SUPPLEMENTARY ASSESSMENT REPORT

**DEVELOPMENT APPLICATION (FURTHER REVISED)
(2016STH035 – DA10.2016.304.1)**

**PROPOSED MIXED USE DEVELOPMENT
RETAIL AND COMMERCIAL PREMISES
AND SHOP-TOP HOUSING**

Various Allotments
Terralong, Akuna and Shoalhaven Streets
Kiama

Figure 2: Building Height Plane Diagram (looking westward)
(courtesy ADM Architects).

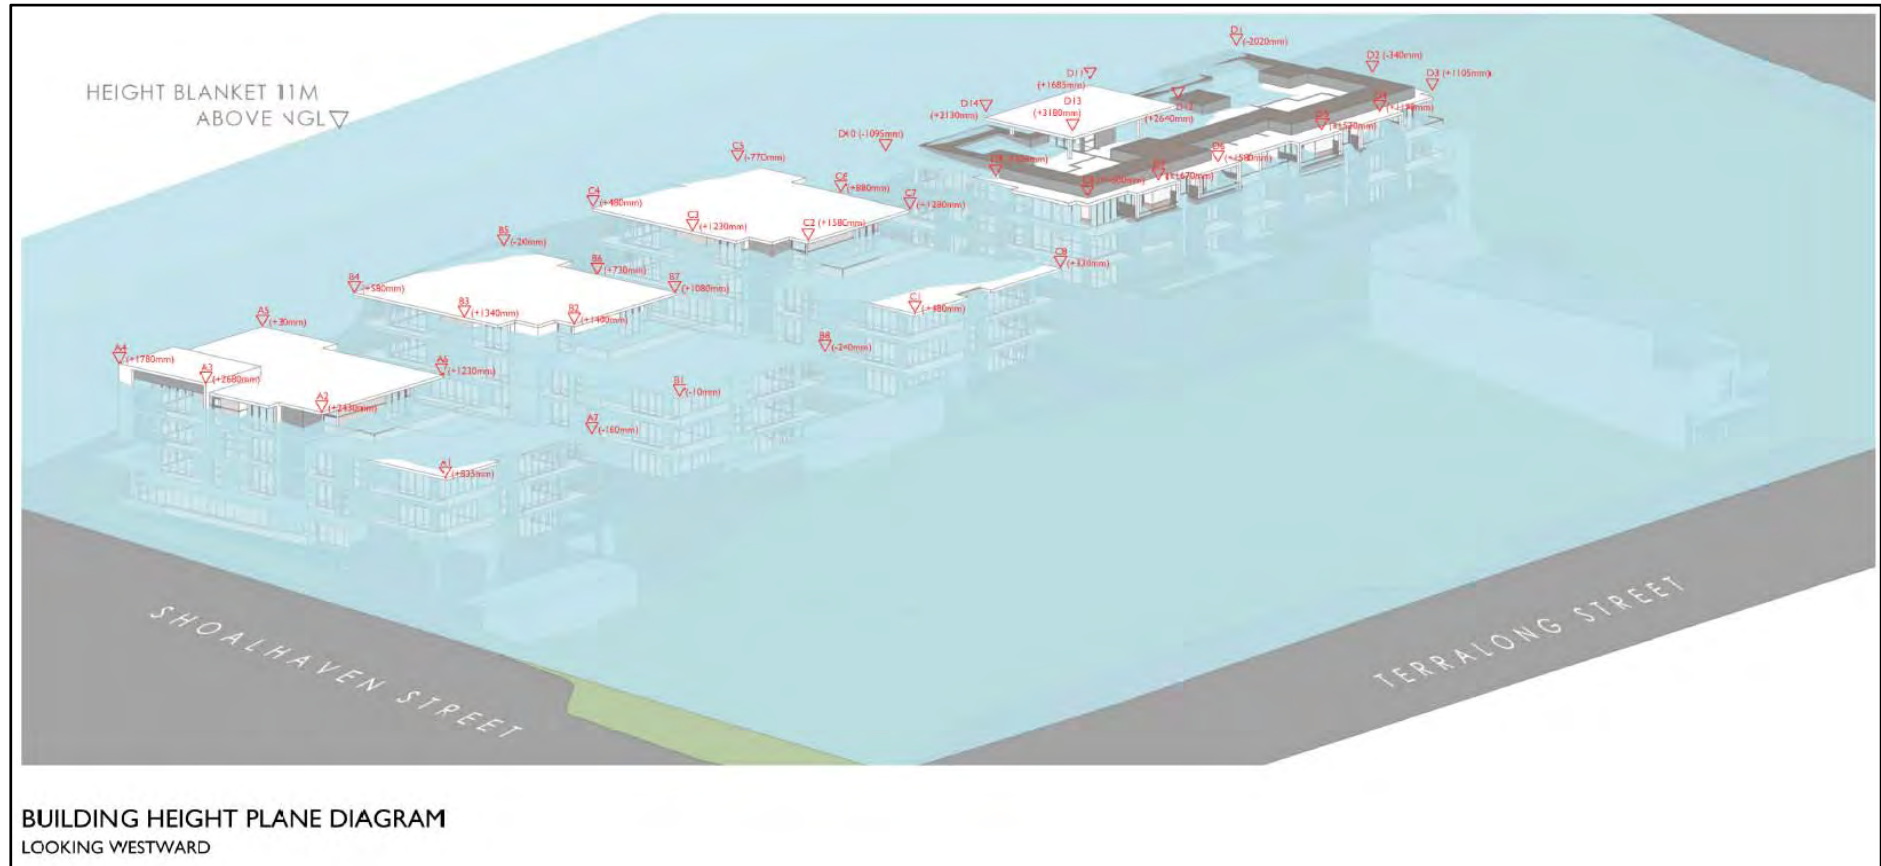
The Applicant has supplied building height plane diagrams which detail the extent of encroachment of the 11 m building height limit. These diagrams are reproduced as **Figures 2 and 3** below.

As detailed in Section 5.2.1 of this report the exceedance of the 11-metre building height for Building D & E, despite the deletion of level 4, has come about as a result of:

- The residential floor levels for Building D & E have also been raised by 1.2 metres from the previous revised proposal. In addition to raising the lobby roof for the communal open space, this has also resulted in the northern parts of the level 3 roof extending above the 11-metre ground level for Building D & E from about 1.1 m at the north-western corner of this building to 1.67 metres towards the north-western part of this building. The rationale for raising these floor levels relates to reducing the height difference between Level 1 apartments and the Akuna Street level improving resident amenity for these units and enabling greater activation of the street frontage.

Figure 4: Extract South Elevation (Akuna Street Aspect) Drawing Number A203 (courtesy ADM Architects).

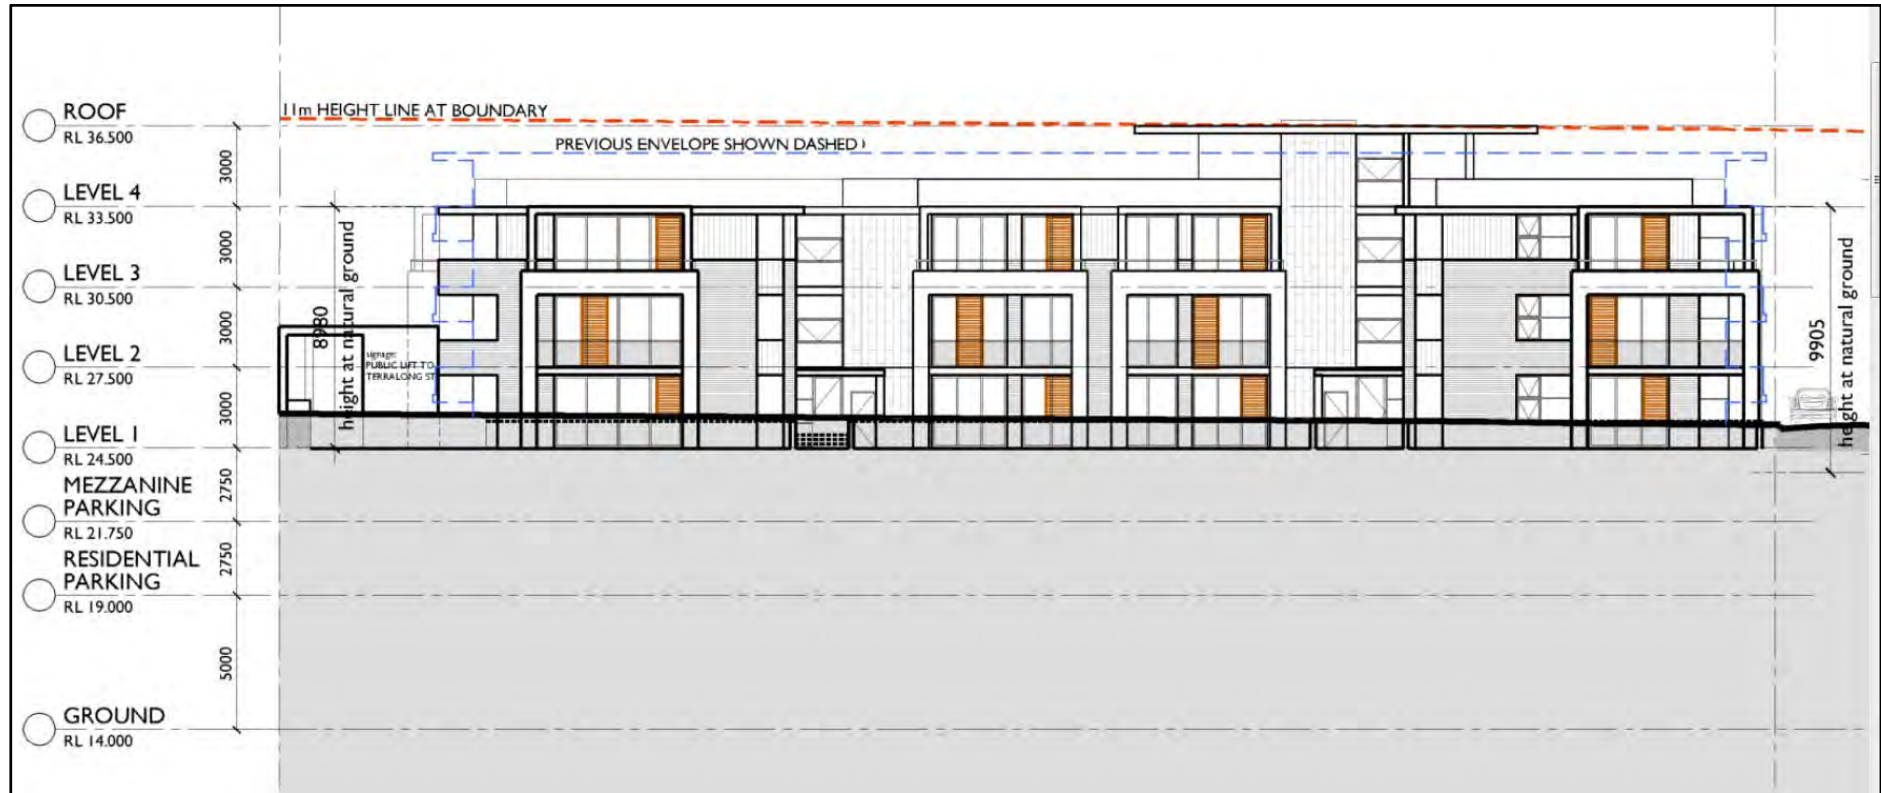
In addition, the southern elevation drawing A-203 which forms part of the Architectural drawing set for the further revised proposal includes a comparison of the further revised proposal when viewed from Akuna Street and the outline of the previous revised proposal. An extract of this elevation is included as **Figure 4** of this report.

As is evident from **Figure 4** above, when viewed from Akuna Street, the development will sit well below the 11-metre building height, and below the outline of the previous revised proposal, with the exception of the lift lobby which will sit within the 11-metre building height limit.

Figure 8: Extract Drawing A-103 showing location of lift and stairwell points in residential arcade (courtesy of ADM Architects).

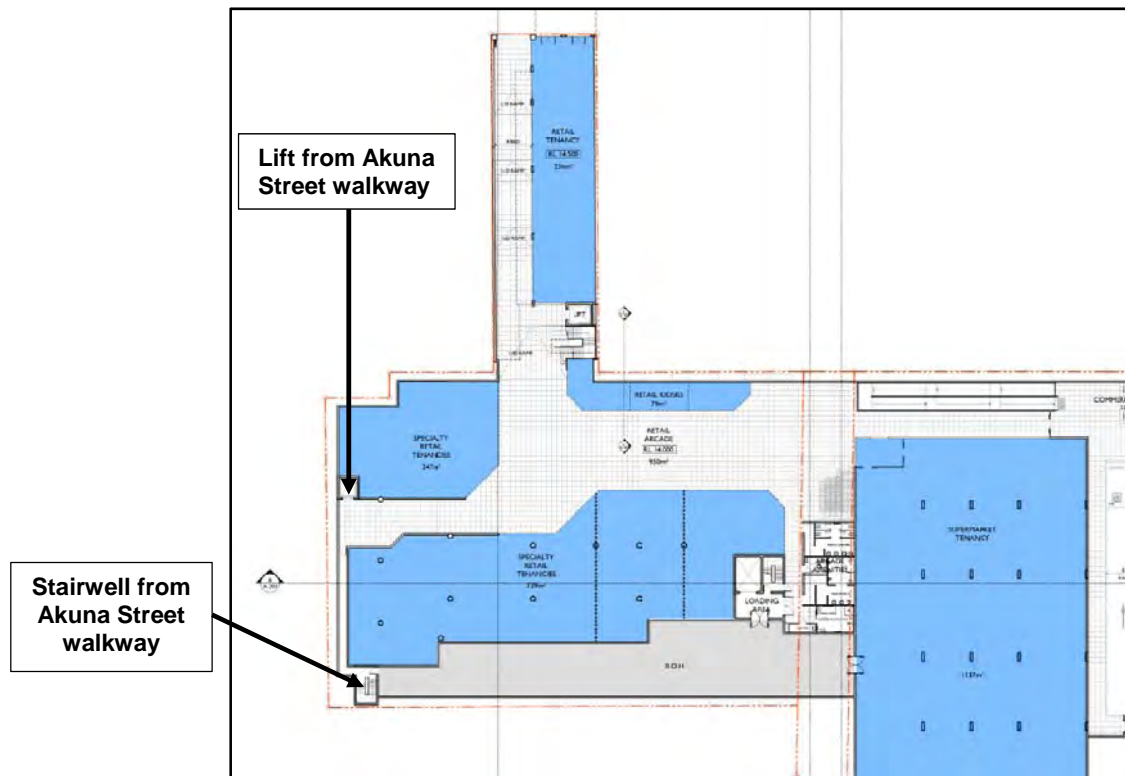
The lift provided at the Akuna Street frontage of the site under the previous revised proposal sought to provide universal access to the ground level retail car park level from Akuna Street; however provided a somewhat circuitous route to Terralong Street through the car park and arcade. This pedestrian access route has now been deleted from the further revised proposal.

The further revised proposal incorporates a new pedestrian walkway extending from the Akuna Street frontage of the site along the western boundary of the development. This
